HYNET CARBON DIOXIDE TRANSPORTATION AND STORAGE PROJECT - OFFSHORE

**RESPONSE TO REQUEST FOR FURTHER INFORMATION –
REGULATION 14(1) THE MARINE WORKS (ENVIRONMENTAL IMPACT
ASSESSMENT) REGULATIONS 2007 (AS AMENDED)**

Technical Note: Physical Processes

WAE02282
04 July 2024

Figure 1-2: Updated Indicative Offshore Power Cable alignment (green line) through West Hoyle Spit to eliminate right-angled bends

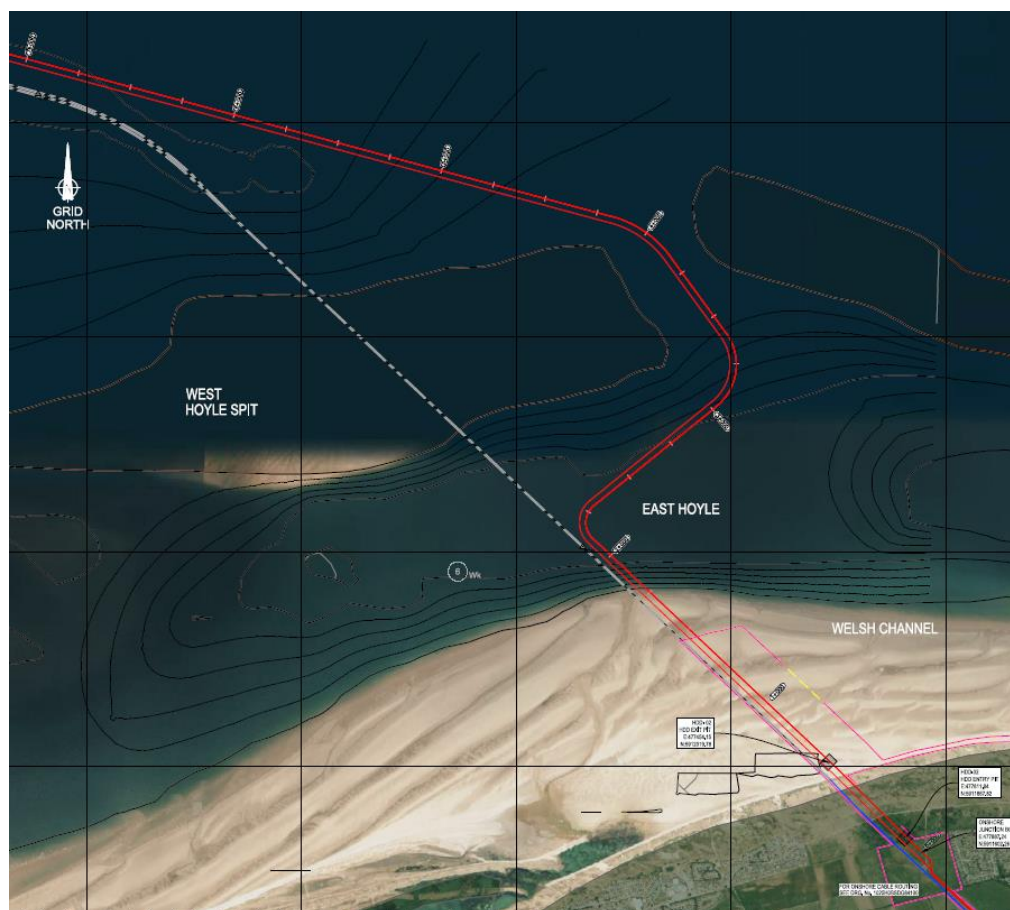
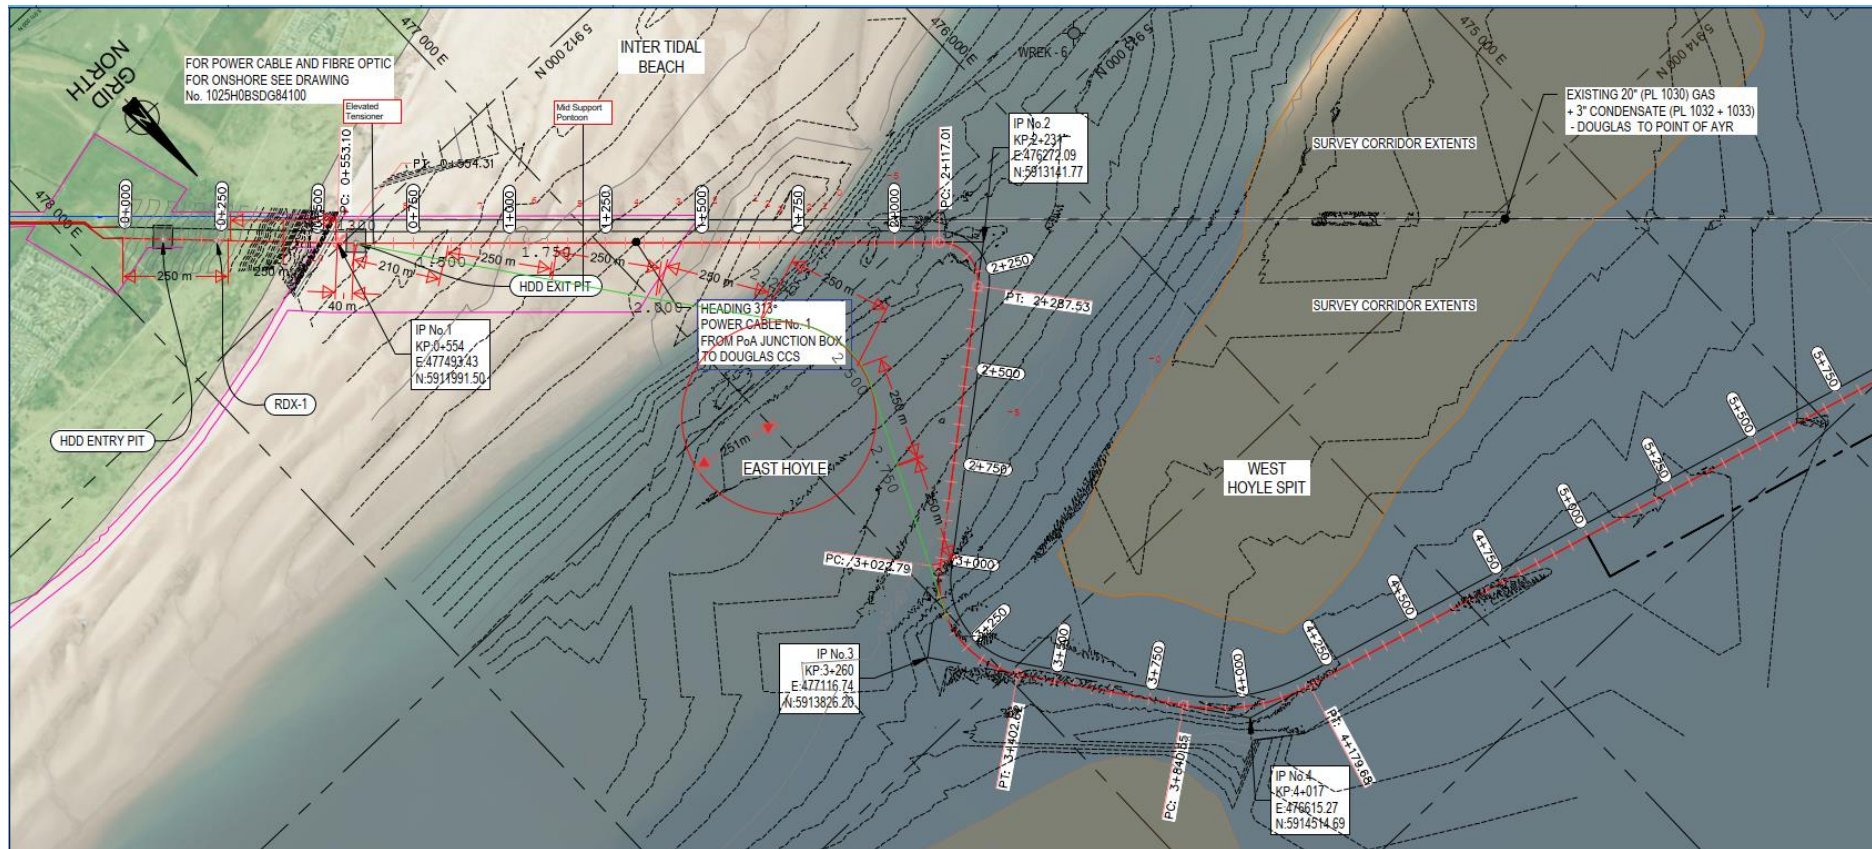
NRW	<p>The potential cumulative impacts of drilling and sand wave clearance within Awel y Môr array area and the activities of the proposed works are assessed. NRW (A) seek clarification whether the value of 50mg/l represents the worst-case scenario, we advise a value representative of a spring flood tide is used to assess the worst-case scenario.</p> <p>An assessment of the maximum SSC values in the area of overlap between the Port of Mostyn Energy Park and the development has been provided (up to 100 mg/l for both plumes combined). However, no assessment has been provided of the combined value of sedimentation due to the proposed works and the Port of Mostyn Energy Park. We advise this value should be provided in order to support the assessment conclusion that the effect will be negligible.</p>	Further information is presented in Section 1.5.
NRW	<p>NRW (A) agree with the conclusion that whilst not a designated feature, West Hoyle Bank influences the wave energy approaching the coastline and</p>	<p>Errata</p> <p>There has been an inconsistency in the naming of the West Hoyle Spit within the ES. There are references to "West Hoyle Bank", which the</p>

Consultee	Consultation	Where and How Addressed
	<p>the exchange of sediments with the adjacent coastline. We also agree that the removal of this sandbank has significant implications to coastal flood risk. We recognise the dynamic nature of sediment transport and morphological features is widely accepted within the scientific community, however, a baseline understanding of the magnitude or variability of the role West Hoyle Bank plays in controlling sediment exchange with the coastline is not provided. We advise that this section requires more detailed evidence such as sand wave migration rates to establish a baseline understanding of the physical processes controlling this feature before the potential impacts of the proposed works are considered.</p> <p>We recognise calculating migration rates would require repeat bathymetric survey data and note the Wales Coastal Monitoring Centre provide additional bathymetric data for West Hoyle Bank (Data Wales Coastal Monitoring Centre (wcmc.wales)).</p>	<p>Applicant appreciates is a different coastal feature located close to Hilbre Island on the east side of the Dee Estuary. This is an editorial error, and all references in the ES to "West Hoyle Bank" should refer to West Hoyle Spit, which is the coastal feature to the north of the Welsh Channel.</p> <p>The Applicant can therefore confirm that there will be no project activities on or in the vicinity of the West Hoyle Bank. There is therefore no proposal to remove the West Hoyle Bank, with the subsequent impacts on coastal protection and the grey seal haul out area. The Project worst-case proposal was to excavate a temporary trench across the West Hoyle Spit to facilitate burial of our proposed electrical cable.</p> <p>Project methodology update</p> <p>On a point of clarification, the Marine Licence application, and Environmental Statement (ES) project description (see Offshore ES Chapter 3) presented two cable route options to negotiate the West Hoyle Spit between the Point of Ayr and the New Douglas platform.</p> <p>The worst case scenario, assessed within the ES, followed in parallel alignment with the existing natural gas pipeline crossing West Hoyle Spit whilst the preferred option, presented in the ES, runs to the east and does not cross West Hoyle Spit. It was never proposed or intended to remove the entire West Hoyle Spit.</p> <p>For the worst case scenario, to take the cable directly across the West Hoyle Spit, would have required dredging a channel (most likely with a barge operated backhoe dredger). This channel would be circa 7 m in depth; with approximately 3 m to take the Bank down to LAT, then approximately 3 m depth for cable burial. The excavated material would be side cast along the length of the trench, and then backfilled after cable installation.</p> <p>Since publication of the ES and submitting the Marine Licence application, the Applicant has been in negotiations with contractors for the supply and installation of the offshore electrical cables. The outcome of these negotiations is that the cables will not be installed across the West Hoyle Spit and will follow the preferred option to the east. Additionally, only one cable will now be installed between Point of Ayr and the New Douglas platform, instead of the two originally proposed. This also means that there will be a simultaneous lay and burial of the electrical cable requiring only one passage of the cable lay vessel between Point of Ayr and the New Douglas platform, instead of the four that would have been needed.</p> <p>This means that the 'worst-case' assessed in the ES will not occur and the West Hoyle Spit will be undisturbed. As a result, the worst-case environmental effects will be avoided and are not predicted to occur.</p>

It should be noted that the project description (see Offshore ES Chapter 3) outlined two potential cable routes between the Point of Ayr and the New Douglas platform. The “worst case scenario” followed in parallel alignment with the existing natural gas pipeline crossing West Hoyle Spit whilst the “preferred option” runs to the east and does not cross West Hoyle Spit. Through the assessment of alternatives process which forms an integral part of any EIA, and ongoing discussions with cable installation contractors, the preferred option has been identified for cable installation and the West Hoyle Spit will remain undisturbed. The cable route will pass

through the natural channel sited to the east of the Spit, as illustrated in Figure 1-1, which shows the alignment presented in the ES. Therefore the future baseline scenario and post construction scenarios in terms of physical processes are indistinguishable in this respect. Further refinement of the preferred route alignment has recently been carried out, as shown in Figure 1-2, which has eliminated the right angled bends along the first 3.25 km of the cable route from the HDD exit pit at the MHS mark on Talacre Beach and around West Hoyle Spit.

Figure 1-4: Typical Schematic Layout of Concrete Mattress Protection at Cable Crossing

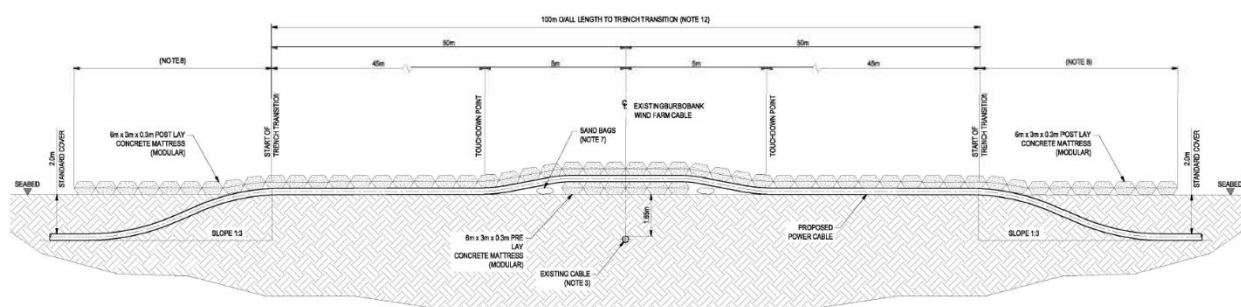
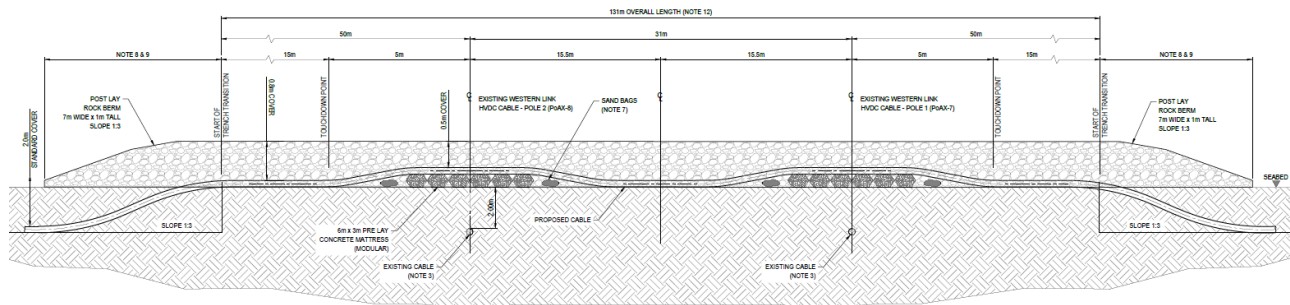
Consultee	Consultation	Where and How Addressed
NRW	<p>NRW (A) seek clarity on the commitment and ability for cable protection height to affect no greater reduction in water depth than 5% where cable crossings are required in 5.8m water depth, equating to protrusion of no more than 0.29m.</p> <p>NRW (A) seek clarification on the course of action in the event the commitment to 'no greater reduction in water depth than 5%' is not practical.</p>	Further information is presented in Section 1.6: Cable crossings in shallow water.
NRW	<p>The assessment of changes to SSC and sediment deposition uses average values from the modelling study. Average values of modelled SSC and sediment deposition values do not represent the worst-case scenario required to appropriately assess secondary impacts to other receptors such as Benthic, Fish and Ornithology. Maximum values of SSC and sediment deposition values are required to determine the significance of secondary impacts of elevated SSC and sediment deposition values arising from the proposed seabed preparation and cable installation works before cumulative impacts can be considered appropriately. NRW (A) advise that the assessment should clearly state how maximum values of SSC and sediment deposition vary with time and distance as a result of works included in the construction phase.</p>	Further information is presented in Section 1.4.

In such cases the design of the cable crossing reduces the potential impacts of physical processes by the use of layered protection which gradually changes in height, as illustrated in Figure 1-4 and Figure 1-5. Each layer of the modular post lay concrete mattress is 0.3 m in height. At the approach to the crossing there will be a single layer of mattressing which then overlays the cable as it emerges from the bed and is surface laid. The cable will then be laid over a single layer of mattressing placed on the bed at the crossing point. This is then covered with either a single layer of mattressing, or rock. For crossings PoAX-1, and PoAX-2 the concrete mattress protection as shown in Figure 1-4, the distance of the touchdown points either side of the crossing is circa 5 m. Therefore the 0.8 m berm height occurs for a limited distance <10 m and for the majority of the crossing the obstruction on the bed is between 0.3 m and 0.5 m in height (i.e. a small proportion of each shallow water crossing exceeds 5% of the water depth). The rock protection for PoAX-4 shown in Figure 1-5 the 0.8 m berm height will occur over its full length of up to 200 m. Therefore, only crossings PoAX-1, PoAX-2, and PoAX-4 will be within very shallow water and will form a gradual reduction in water depth, lowering the potential impacts of physical processes.
